SCHWEIZER SERVICE BULLETIN

B-266
15 Oct 1996

SUBJECT: TEXTRON LYCOMING SERVICE BULLETIN NO. 525

SUBJECT: Inspection of High Pressure Fuel Pump P/N LW-15473

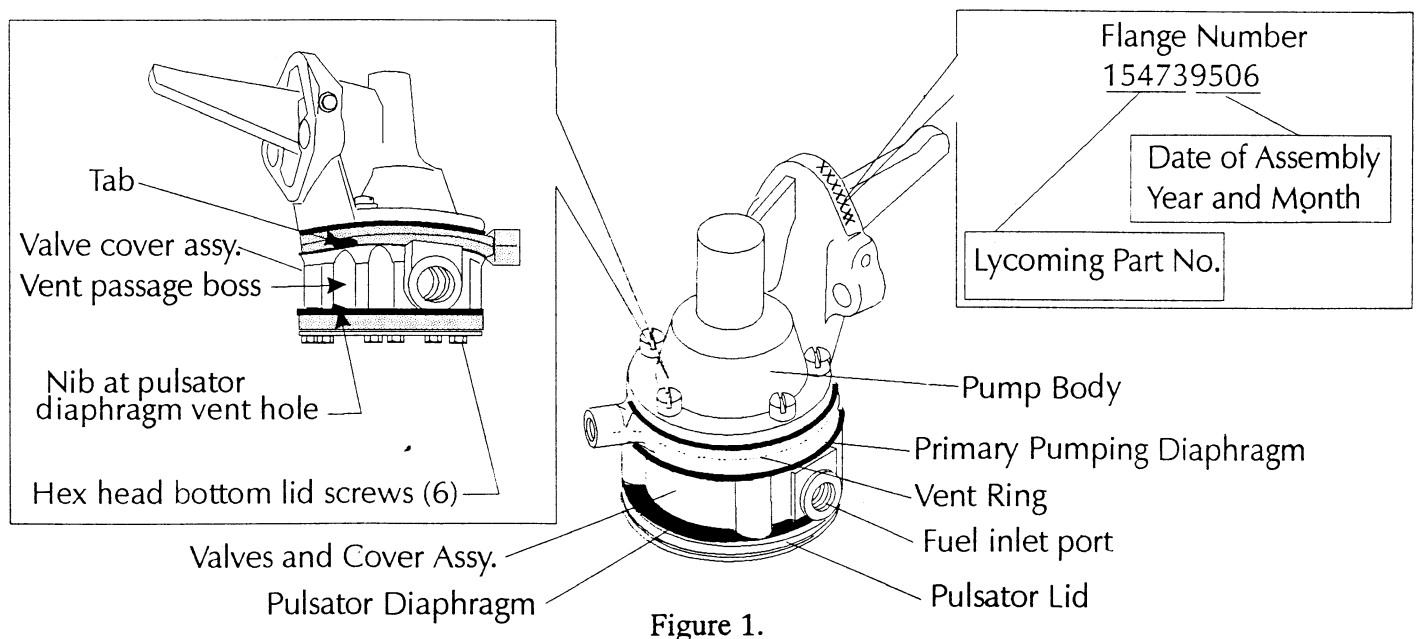
1. Remove the fuel pump from the engine.
2. With a felt tip marker, make a line down the side of the pump assembly at the vent passage boss (Refer to Figure 1) to aid in part alignment for subsequent reassembly.

3. Completely loosen but do not remove the six hex head bottom lid screws and remove the entire bottom section of the pump as a unit assembly including the lid screws and valve cover assembly. (Refer to Figure 1.) Set this unit assembly aside for later examination (step 7).

7. Examine the pulsator diaphragm from the unit assembly set aside in step 3, (Refer to Figure 1) as follows:
 - a. Remove the valves and cover assembly from the six hex head retaining screws and remove the diaphragm.

11. To identify that this examination was accomplished on the pump assembly, mark an “A” by metal stamp or scribe on the pump mounting flange immediately before the flange number (Refer to Figure 1.) If necessary due to space constraints, the “A” may be located just above the rocker shaft pin. An entry in the engine and/or aircraft log book should also be made.
 12. If the pump was removed for examination, reinstall it per standard practice according to the appropriate Overhaul Manual. Examine the port fitting “o” ring seals and the mounting flange gasket, replace if necessary.
- Once the pump is reinstalled on the engine, run the engine on the ground and inspect the pump and fuel lines for fuel leaks.

Figure 2.

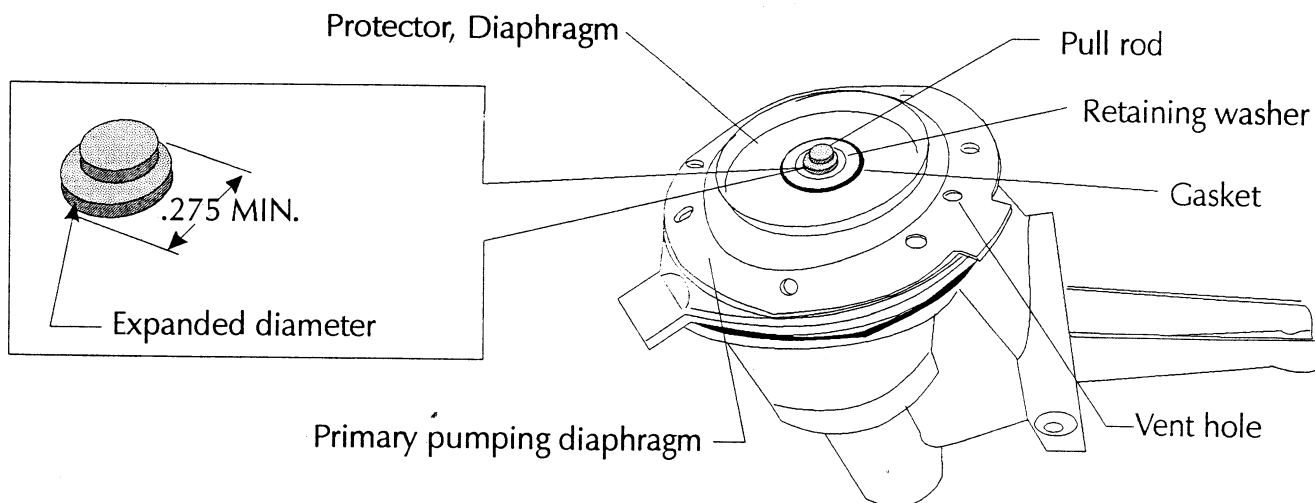
4. Visually inspect for proper location and retention of the gasket in the pull rod/diaphragm assembly. (Refer to Figure 2.) If the gasket is not found to be between the retaining washer and diaphragm protector or it protrudes more than 1/16 inch beyond the retaining washer at any point, the pump is unserviceable and must be replaced.

5. Using vernier or dial calipers, measure the expanded diameter of the pull rod section immediately next to the retaining washer (larger copper plated diameter). If this diameter measures less than .275 inches, the pump assembly is unserviceable and must be replaced.

Figure 3.

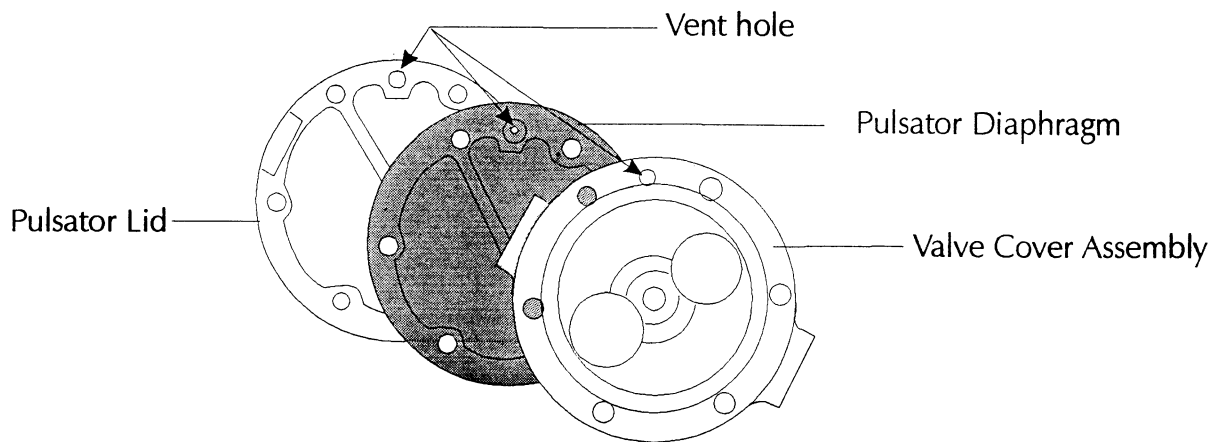
8. Place the pulsator diaphragm over the pulsator lid, aligning the small hole near the diaphragm periphery with the lid chamber vent hole. (Refer to Figure 3.)
9. Place the valve cover assembly on the diaphragm, aligning the vent passage with the diaphragm and lid vent holes.
10. Using the alignment mark made in step 2 as a guide, reassemble the “unit assembly” to the pump body observing the correct orientation of the fuel ports. The valves and cover assembly vent passage must align with the tab on the primary pumping diaphragm. (Refer to Figure 1.) Looking at the pump from the rear as installed on the engine, the fuel inlet port is on the right. Torque the six hex head lid screws alternately and evenly until a torque value of 30 inch pounds is obtained.
